S/N 10/560,700

Amendments to the Drawings:

REMARKS AND ARGUMENTS

FIG. 9a

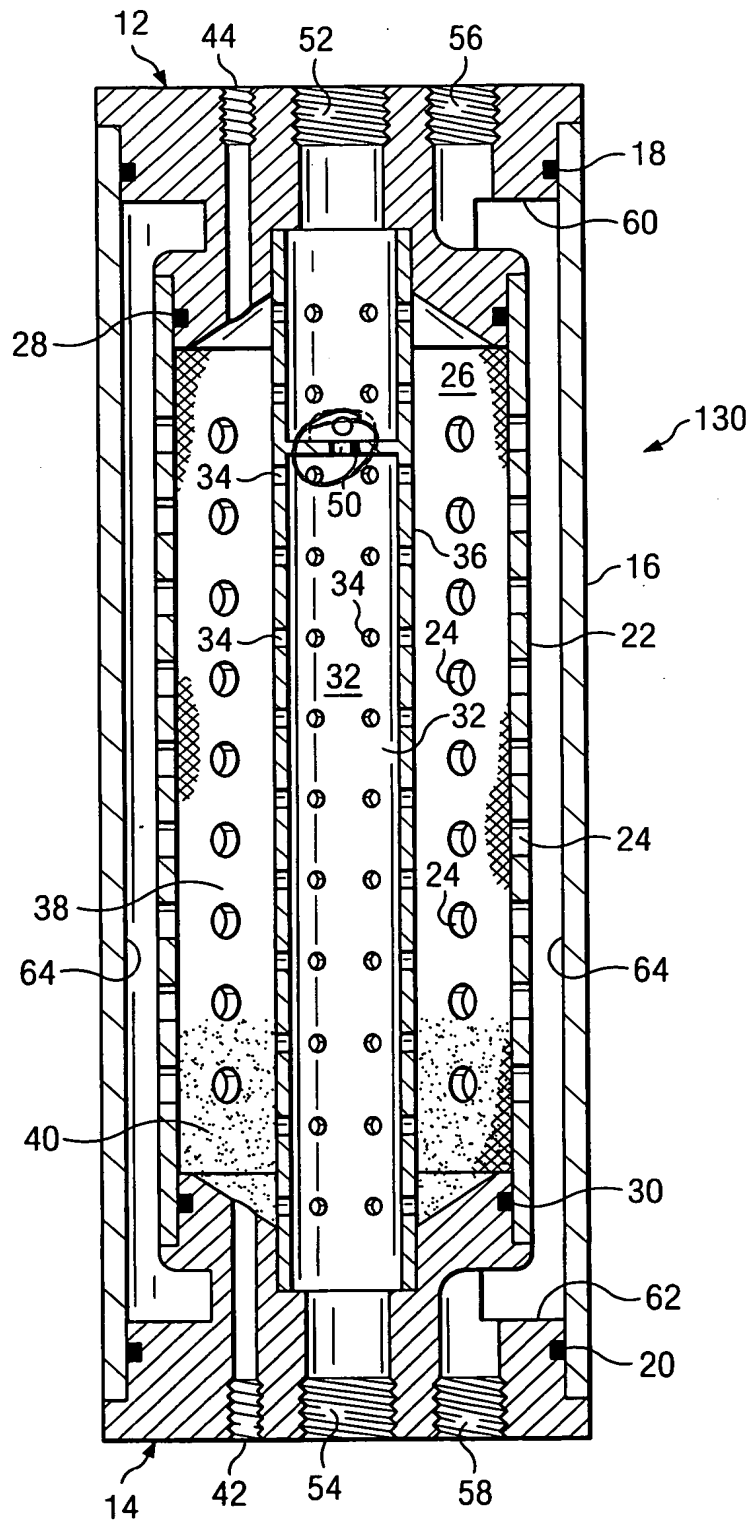
The attached sheets of drawings include changes to Fig. 9a and Fig. 15. These sheets, which include Fig. 9a on sheet 8 of the drawings, and Figs. 14 and 15 on sheet 11 of the drawings, include an omission. The valve 50 did not show a hole therein, in the original drawings of Figs. 9a and 15. Figs. 1b, 2, 3 do show the hole in the valve 50. The hole in the valve plate 50 is described at page 13, lines 17-21 of the specification. No new matter has been added. The replacement sheets 8 and 11 show the hole in the valve plate 50.
